**STAFF REPORT  
ACTION REQUIRED**

**Four Area-Specific Amendments to Chapter 694  
Concerning Third Party Ground Signs Located on Rail  
Lands Immediately Adjacent to Highways 401 and 427**

<b>Date:</b>	June 3, 2014
<b>To:</b>	Planning and Growth Management Committee
<b>From:</b>	Chief Building Official & Executive Director, Toronto Building
<b>Wards:</b>	Ward 2, Ward 12 and Ward 40
<b>Reference Number:</b>	PG14006

Figure 1: Key Map - Proposed location of Sign #1

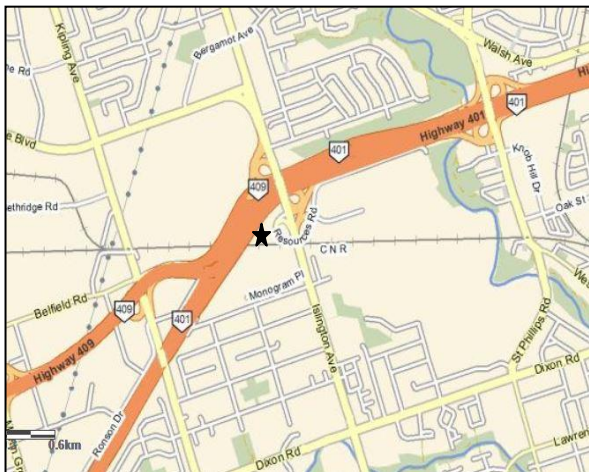
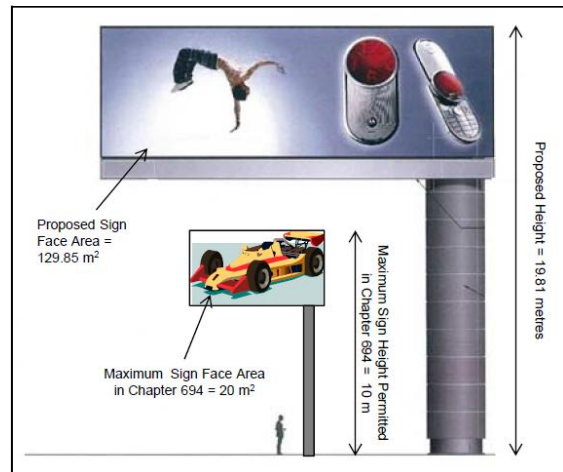
Sign #1 is proposed to be located north of the railway tracks and within the railway corridor defined as the Weston Subdivision, approximately 340 metres west of Islington Avenue and approximately 200 metres east of the interchange of Highways 401 and 409.

There are residential developments approximately 285 metres to the southwest of the proposed sign. The recently completed Illuminated and Electronic Sign Study determined that electronic signs with a height of 10 metres and a sign face area of 20 square metres should not face any properties within 250 metres of the sign. With the proposed sign being almost twice as tall and having sign face area more than six times larger than contemplated by the Illuminated and Electronic Sign Study, it is likely that a separation distance of 285 metres will not be sufficient to mitigate the impacts of the proposed sign on these residential uses.

**Figure 3: Key Map Proposed location of Sign #2**

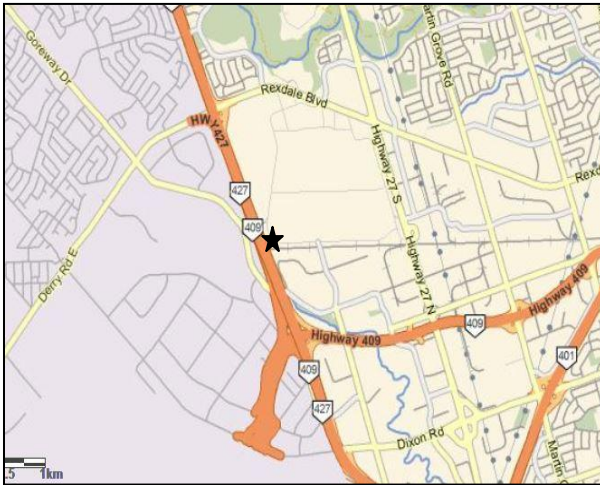
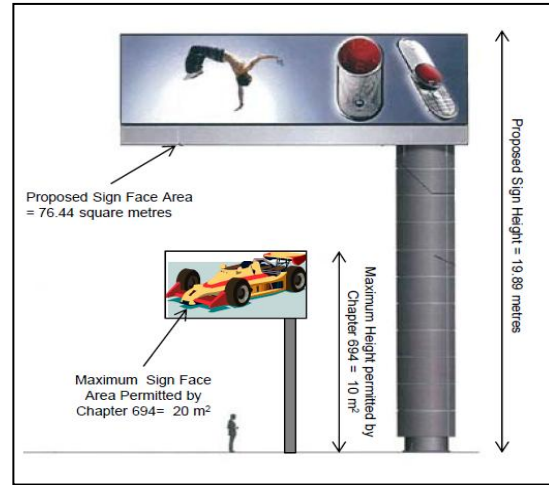
Sign #2 is proposed to be located north of the railway tracks and within the railway corridor defined as the Weston Subdivision, approximately 1500 metres south of Rexdale Boulevard and approximately 900 metres north of the interchange of Highway 427 and Highway 409.

Approximately 500 metres to the south of the proposed sign, there is an open space area containing the North Mimico Valley Park. Similar to Sign #1, with the proposed sign being almost twice as tall and having a sign face area almost four times as large as that contemplated in the Illuminated and Electronic Sign Study, it is likely that the distance between the proposed sign and the parkland will not be sufficient to fully mitigate the impact of the proposed sign on the park.

**Figure 5: Key Map - Proposed location of Sign #3**

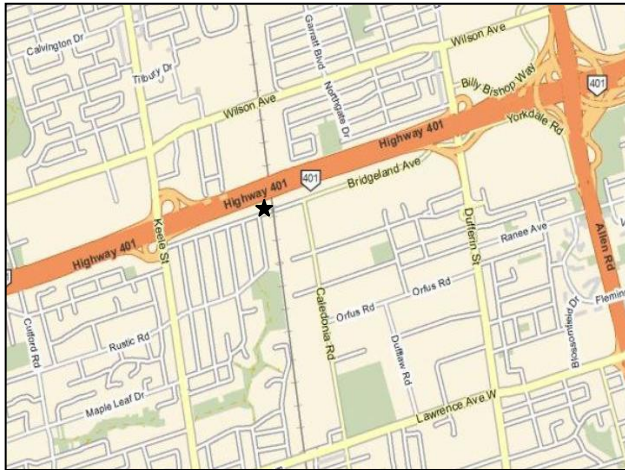
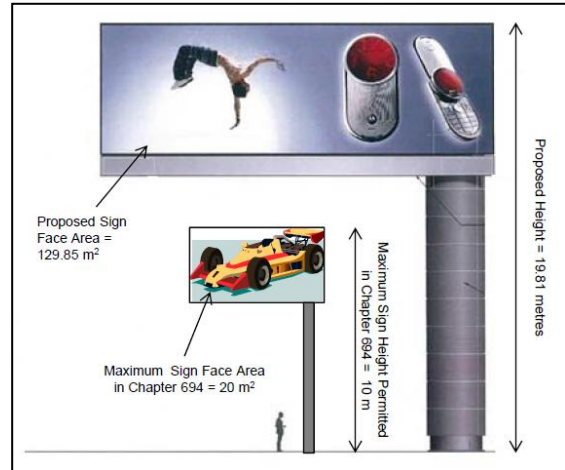
Sign #3 is proposed to be located to the west of the railway tracks and within the railway corridor defined as the Newmarket Subdivision, approximately 720 metres east of Keele Street and approximately 1200 metres west of Dufferin Street.

There are three other third party signs within 100 metres of the proposed ground sign, none of which are proposed to be removed as part of this application. The addition of a fourth sign will contribute to existing sign clutter in the immediate area.

There are residential developments 260 metres to the north-west and 175 metres to the north-east of the proposed sign. With the proposed sign being almost twice as tall and having a sign face area more than six times as large as that contemplated in the Illuminated and Electronic Sign Study, it is likely that the separation distances of 175 metres and 260 metres will not be sufficient to mitigate the impact of the proposed sign on these residential developments.

Figure 7 - Key Map - Proposed Location of Sign #4

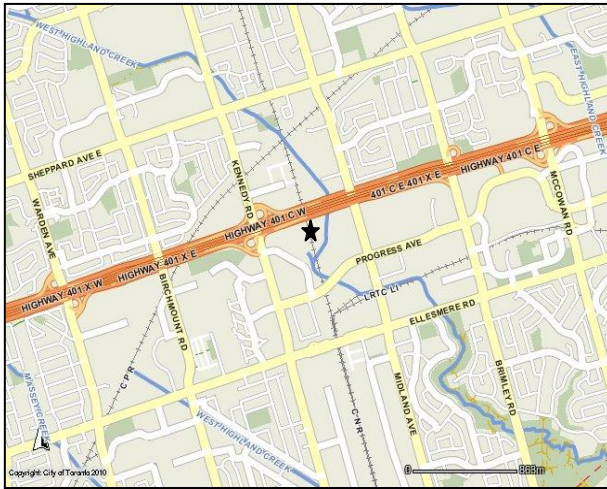
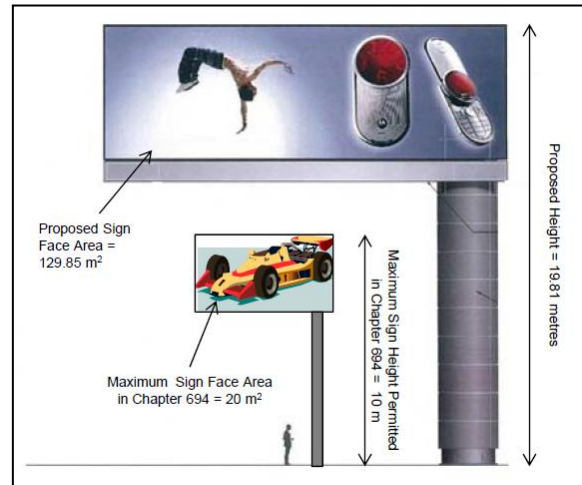
Sign #4 is proposed to be located to the west of the railway tracks and within the railway corridor known as the Uxbridge Subdivision, approximately 400 metres east of Kennedy Road and approximately 400 metres west of Midland Avenue.

This sign is located in the former Municipality of Scarborough where, unlike other parts of the City, the Zoning Bylaw(s) regulate the placement of third party signs. The property in question has not been incorporated into the new city-wide Zoning Bylaw and is still subject to the former Scarborough zoning requirements for third party signs.

Based on the Scarborough Zoning Bylaw No.24982 (Employment Districts), third party signs have been classified as a type of development that is not permitted in this area. In addition to relief from the requirements of Chapter 694, an amendment to the Scarborough Zoning Bylaw would be required to permit a third party ground sign to be located where Sign #4 has been proposed.

There are also residential developments 450 metres to the north-west of the proposed sign. With the proposed sign being almost twice as tall and having a sign face area more than six times as large as that contemplated in the Illuminated and Electronic Sign Study, it is likely that a separation distance of 450 metres will not be sufficient to mitigate the impact of the proposed sign on nearby residential uses.
